Project:	2022-RFT-030 821131– Solid Waste Landfill Construction		
Addendum No.	02	No. of Pages:	8
Date:	2022-05-13	Doc. No.:	P7201-1591092266-153(1.0)

The purpose of this Addendum is to clarify and answer for bidder's question on tender 2022-RFT-030 issued for bid on April 19, 2022

Compacted Granular A is acceptable as anchor trench backfill.

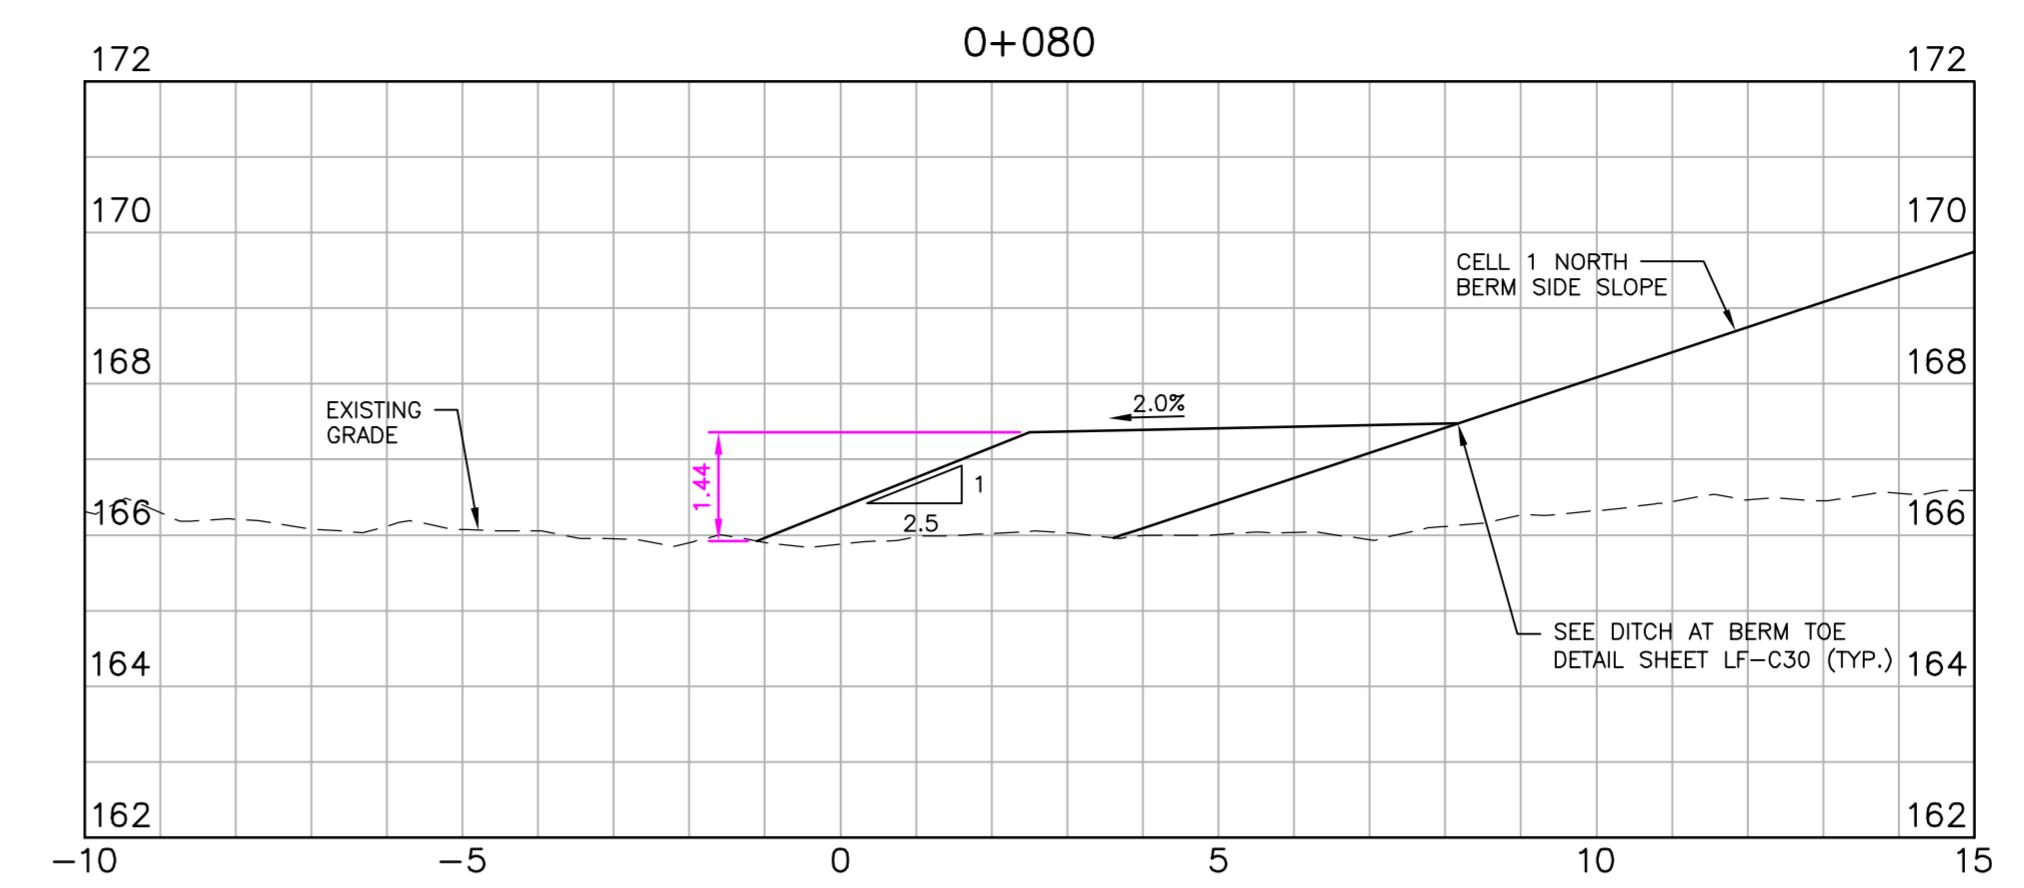
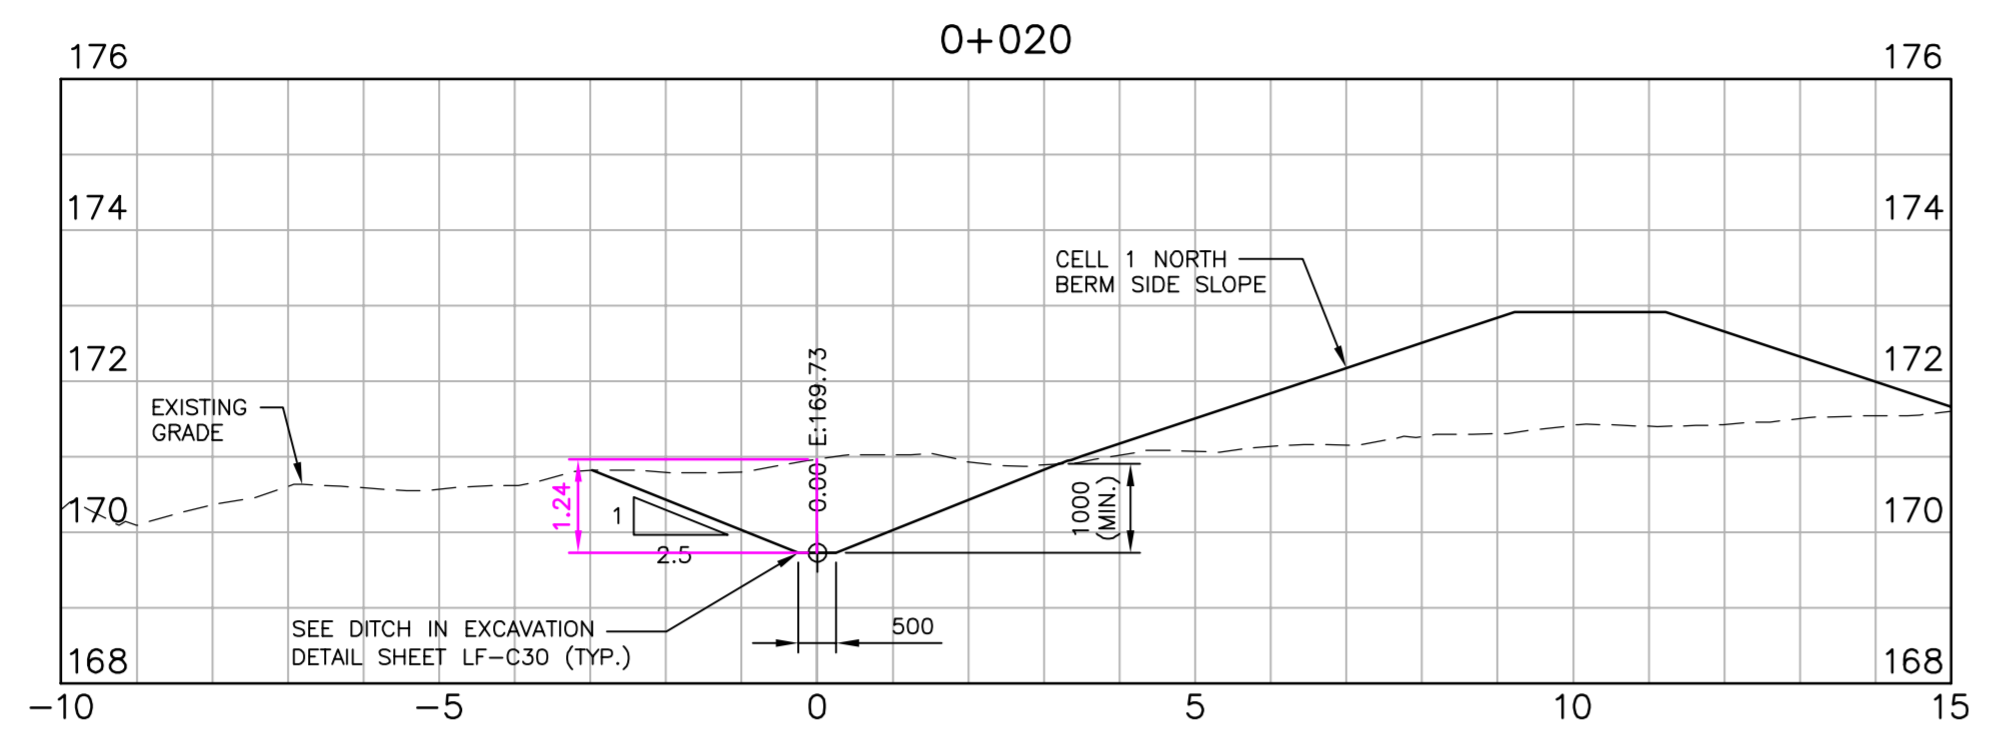
Please confirm limits of liner and geotextile for ditch as width is not clear ([Cell 1 Ditch Liner and Geotextile RFI.pdf](#))

Please see attached Item 1A and 1B.
